**Description: Erection of replacement dwelling and garage, relocation of access and associated works**

**Address: Appleford, Bowcombe Road, Kingsbridge TQ7 2DJ**

**PLANNING REF: 3943/20/FUL**

## **LETTER OF REPRESENTATION FROM THE SOUTH HAMS SOCIETY**

Image 7

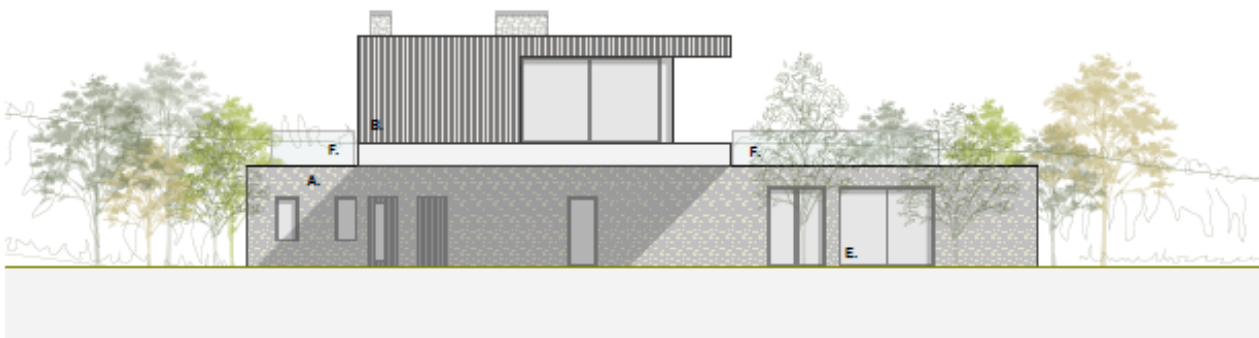
This design can only be described as ultra-modern. Is it suitable for this sensitive location?

In terms of visual impact, it is clear that as the new building at Appleford shifts nearer the road and into the estuary and creek view (as illustrated by the overlay plans above), its visibility will substantially increase. **It will also be highly visible from the Charleton PRow.**

The South Hams Society believes that the proposed development introduces a new and inappropriate built form into this highly sensitive estuary setting. Sadly, we already know what oversized modern houses do to this setting – see Image X below. It will be another unwelcome intrusion into an already threatened location within the Undeveloped Coast.

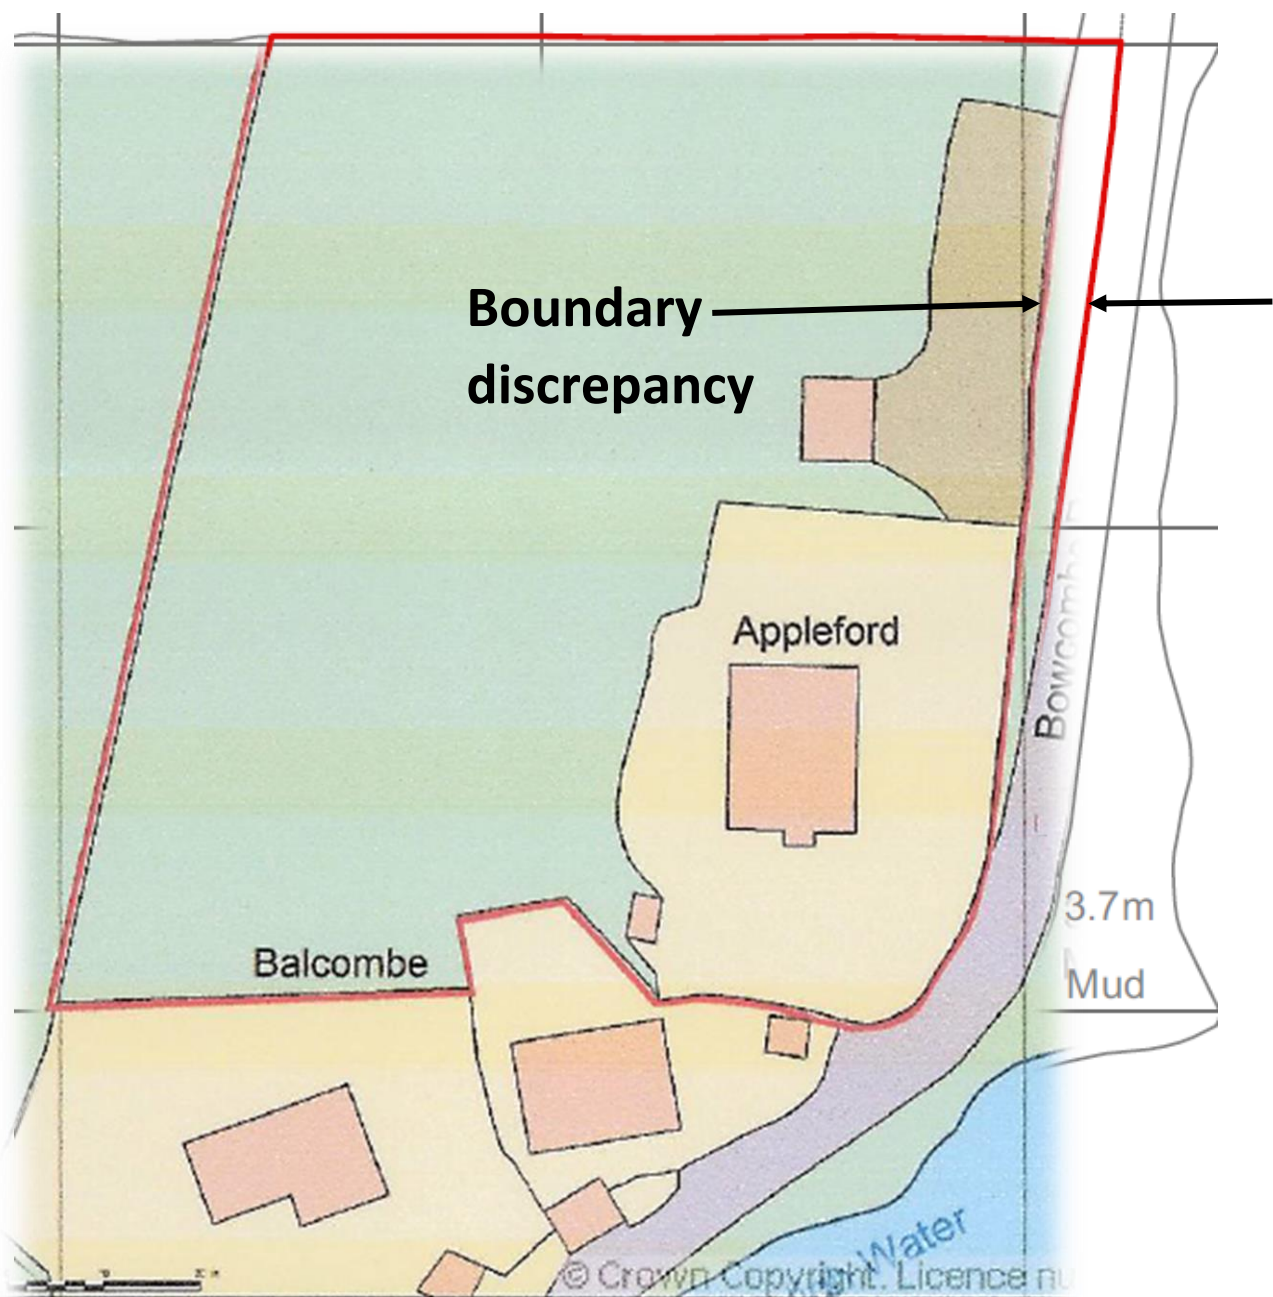
We strongly believe that it will inevitably have significant adverse impacts on the natural beauty, special qualities, distinctive character, landscape and scenic beauty of the site.
